## Technical Notification

Document number: 95-137253-A

### SAILOR 500 FleetBroadband, SAILOR 250 FleetBroadband, SAILOR 150 FleetBroadband, EXPLORER 727 & EXPLORER 325 – SW ver. 1.16

### Selecting 3.1 kHz Audio (fax)

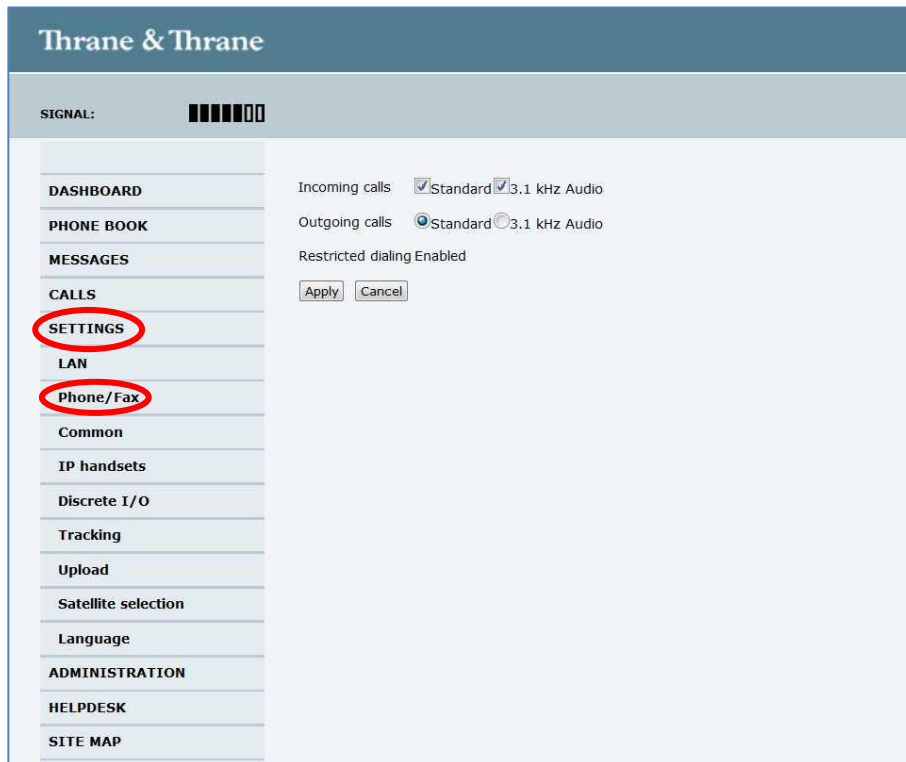
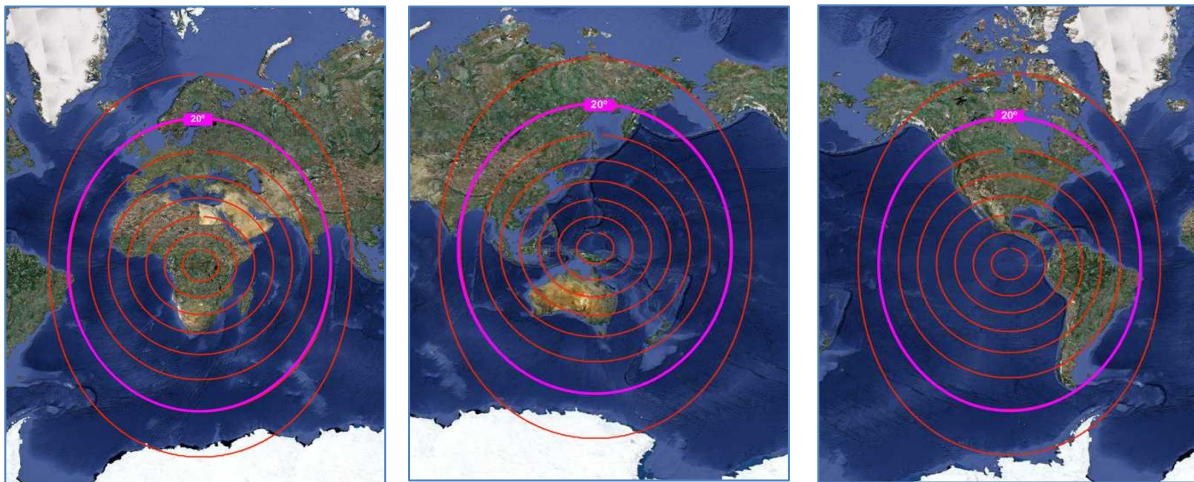
- **New features and improvements** related to SAILOR 150 FleetBroadband:
  - 3.1 kHz Audio (see Appendix I)
    - Support for 3.1 kHz Audio and fax (above 20° elevation).
- **New features and improvements** related to SAILOR 500 FleetBroadband, SAILOR 250 FleetBroadband and SAILOR 150 FleetBroadband:
  - Improvements and optimization in relation to antenna control.
  - Improvements in relation to FleetBroadband Multi-voice.
    - To supplement these improvements a new IP Handset software: SW ver. 1.14, is now also available.

2. When a fax is connected on the RJ11 port, choose only  (check mark) **3.1 kHz Audio** as **Incoming calls** (both boxes can be selected at the same time, but Standard is not needed for fax service) and  (dot) **3.1 kHz Audio** as **Outgoing calls** (only one dot can be set).

**NOTE:** If **Outgoing calls Standard** is selected and applied, the fax will not be reaching the receiver, as the service will be wrong.

The **3.1 kHz Audio** service for SAILOR 150 FleetBroadband is only available with elevation angle above 20° (pink line on above pictures).

1. From the **DASHBOARD** left navigation pane, select **SETTINGS** → **Phone/Fax**.

**NOTE:** Above picture is showing the default setting of the RJ11 port.

3. Click **Apply**.
